BROWNS FERRY NUCLEAR PLANT (BFN) – UNITS 1, 2, AND 3 – TECHNICAL SPECIFICATIONS (TS) CHANGES TS-431 AND TS-418 – EXTENDED POWER UPRATE (EPU) – RESPONSE TO ACRS MEMBER CONCERNS AND RECOMMENDATIONS REGARDING CREDITING CONTAINMENT OVERPRESSURE (COP) CREDIT

RESPONSE TO MARCH 18, 2009 ACRS LETTER CONCLUSIONS AND RECOMMENDATIONS REGARDING CREDITING CONTAINMENT OVERPRESSURE (COP) CREDIT

RESPONSE TO NOVEMBER 10, 2008 ACRS LETTER CONCERNS REGARDING CONTAINMENT OVERPRESSURE (COP) CREDIT FOR BFN EPU

COMPARISON OF BFN EPU LOCA CONTAINMENT OVERPRESSURE (COP) CREDIT WITH
OTHER EPU BWRs

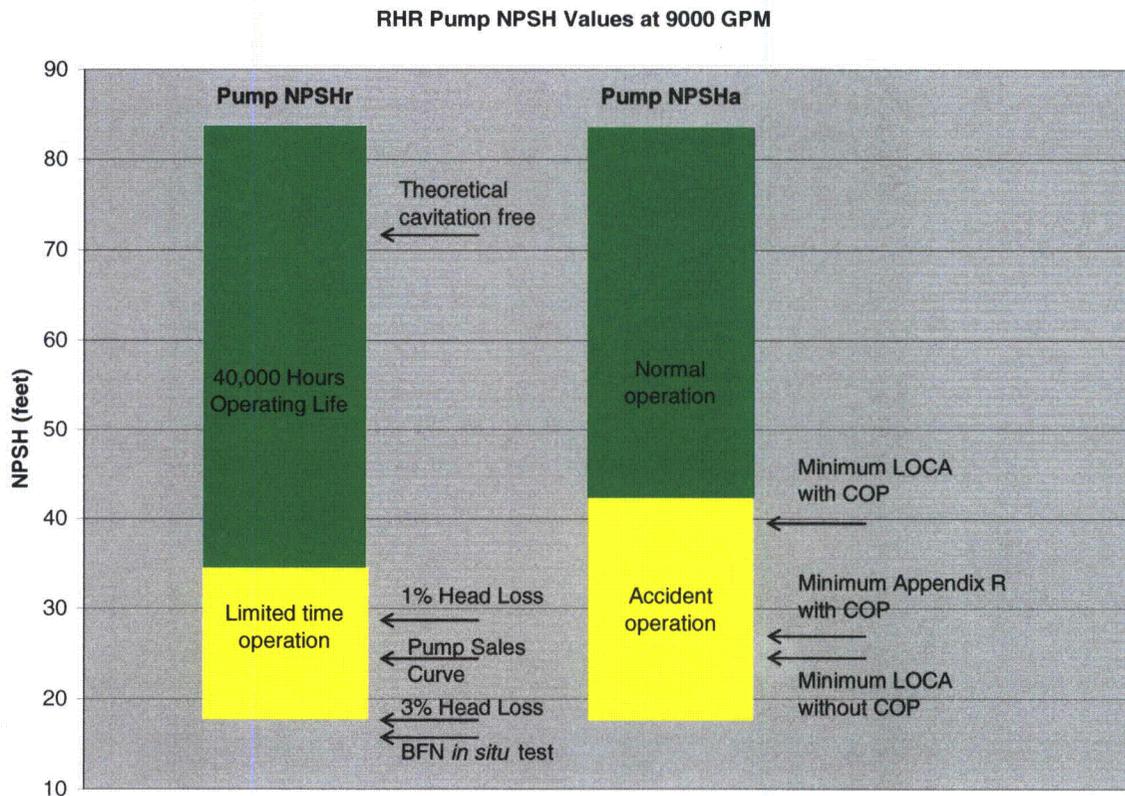
In determining the required NPSH for given flow conditions, the pump vendor establishes required minimum NPSH values that correspond to operation at some degree of cavitation corresponding to 1% or 3% head loss.

- a) *For Browns Ferry RHR and CS pumps, explain if the 3% head loss was always used in determining the required NPSH or was the 1% criteria initially used for the Browns Ferry pump performance evaluation.*

In the past (prior to EPU), the NPSH/COP calculations used NPSHr values that were based on the original vendor performance testing conducted on each of BFN pumps commonly called the sales curves. The original RHR pump sales curve NPSHr values are approximately midway between the 1% and 3% head loss curves shown in Curve 2 of the BFN Sulzer report. For CS, the NPSHr values were also based on the CS pump sales curves and are greater than the 1% head loss curves at mid-range flows and approximately midway between the 1% and 3% head loss curves at high flows. A copy of the Sulzer report was included in the June 12, 2008, submittal.

Beginning in 2006, the EPU NPSH/COP analyses were performed with the pump vendor developed NPSHr values based on operation at reduced NPSH values for limited periods of operating time. These NPSH values are given in Curve 3 and 6 of the Sulzer report and are lower than the pump sales curves for short-term operating durations. TVA submitted the NPSH/COP calculations that used the 8000-hour NPSH values in the previously referenced August 31, 2006, calculations submittal.

In the alternative fire analysis NPSH calculation results that were provided in the June 12, 2008, submittal and later in the revised Appendix R licensing basis analysis results submitted on March 12, 2009 (ML090720951), TVA started using the 3% NPSHr values from Curve 2 of the Sulzer report for the RHR pumps. ANSI/HI 9.6.1-1998, "Centrifugal and Vertical Pumps for NPSH Margin" defines NPSHr as the NPSH that will cause total head to be reduced by 3%. Use of the 3% curves provided a reduction of several feet in NPSHr and lessened the magnitude and duration of required COP. The below figure illustrates the NPSH values that have been used to evaluate RHR pumps in relationship to pump operation.
